Acoustical Wall and Floor/Ceiling Report

38th and SE Belmont Apartments

June 1, 2013

Wall and Floor/Ceiling Review and Recommendations:

1. As Designed:

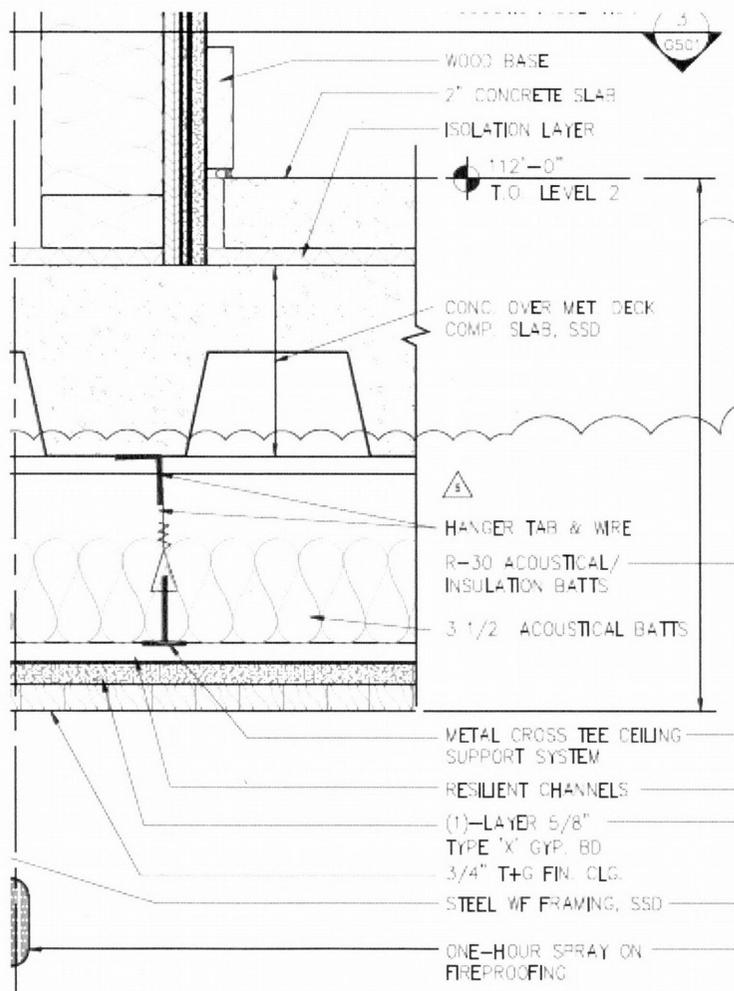
- a. Floor/Ceiling OPTION 1: 2" topping slab, acoustical mat, 2-1/2" concrete over 3" metal deck, wire hangers, 3" minimum air gap, 3-1/2" acoustical batts, RC channels, one layer 5/8" gwb, 3/4" nominal T&G ceiling face. This is a non-standard flooring system with no tested lab ratings for STC or IIC. Based on our models and on similar lab rated assemblies the STC is approximately 54-57 and the IIC is 54-57. This assembly is predicted to be at or above the target STC and IIC, and well above code minimums.

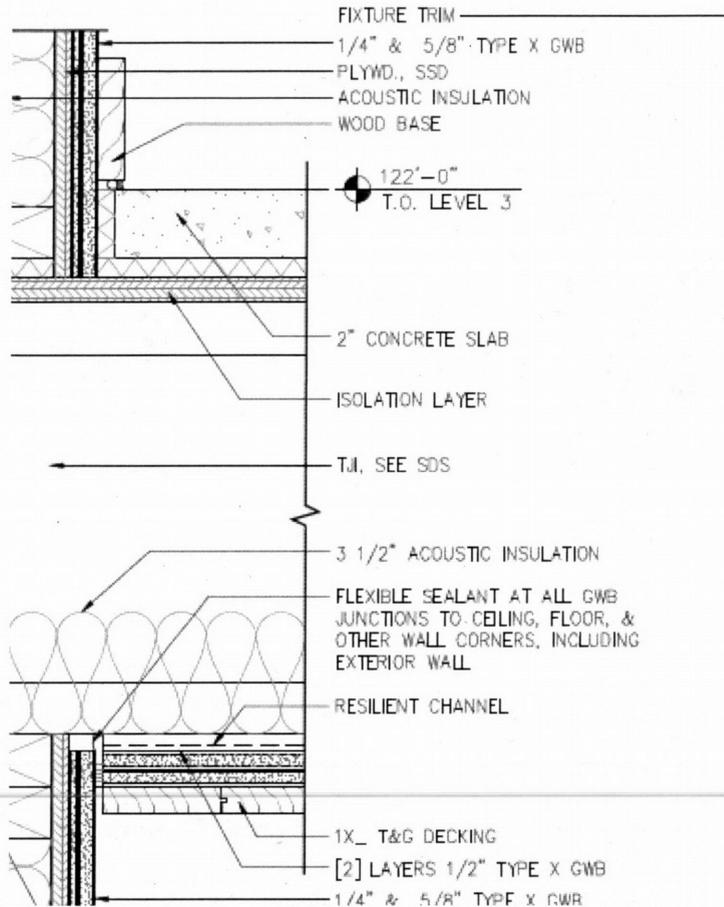
- b. Floor/Ceiling OPTION 2: 2" topping slab, acoustical mat, 3/4" plywood decking, 12" air gap, 6" batts in cavity, 2 layers 5/8" gwb on RC channels. Based on our models and on similar lab rated assemblies the STC is

approximately 58-62 and the IIC is 54-58. This assembly is predicted to be at or above the target STC and IIC, and well above code minimums.

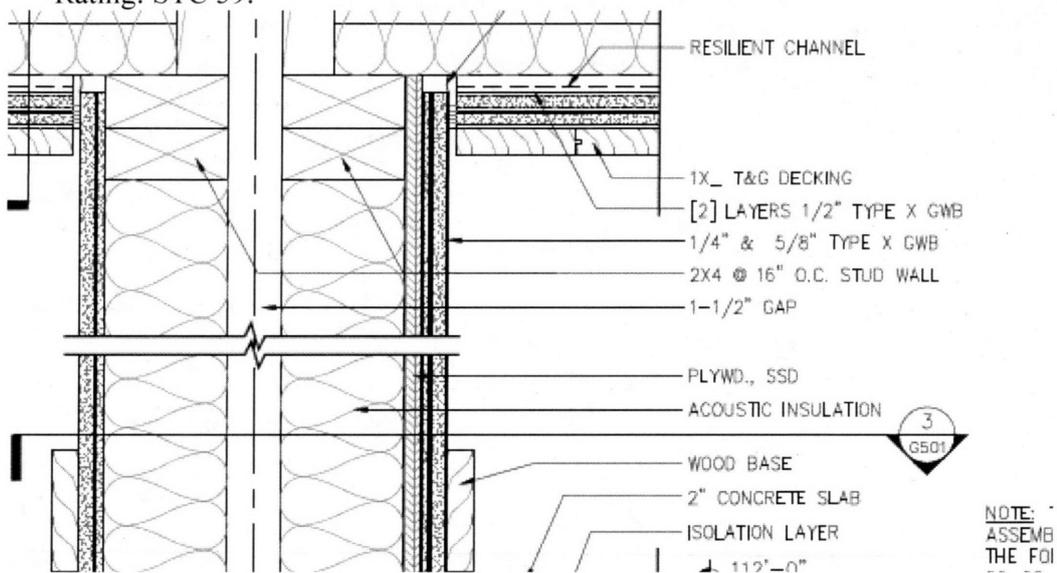
1. As Designed: Double Stud: two 4" wood studs on separate tracks, 16" o.c. with 1 layer 5/8" and one layer 1/4" Type X gypsum board on one side, 1 layer 5/8" and one layer 1/4" Type X gypsum board on other side with 4" batts in both cavities. Rating: STC 59.
